# Monitoring Report MY03

**Sandy Bridge Restoration Site  
DMS Contract 6400  
DMS Project Number 96920**

Re: Response to Sandy Bridge Farm MY03 Report Comments

<b>River Basin:</b>	Broad
<b>Site:</b>	Sandy Bridge
<b>XS ID</b>	XS4
<b>Drainage Area:</b>	837 acres
<b>Date:</b>	6/19/2019
<b>Field Crew:</b>	T. Seelinger, A. Gutierrez

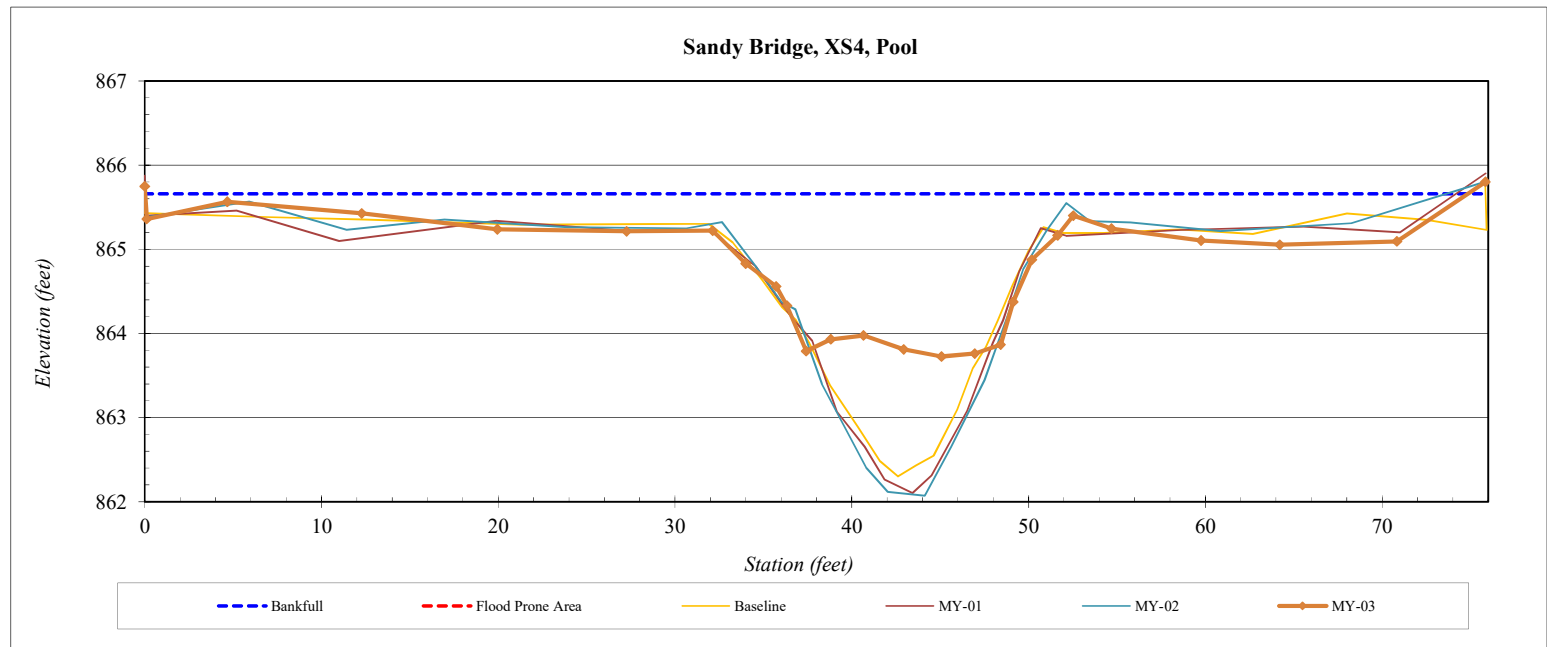
2. Cross section 4 shows repeated values on the vertical scale. Please correct.  
*KCI Response: This issue has been corrected.*
3. Please indicate whether KCI (during downstream repairs) removed the multiple loose tubular steel gates around the relict beaver dam near the upstream end of the project (see MY02 report comment).  
*KCI Response: These were removed during the repair of the non-project stream in November 2019.*
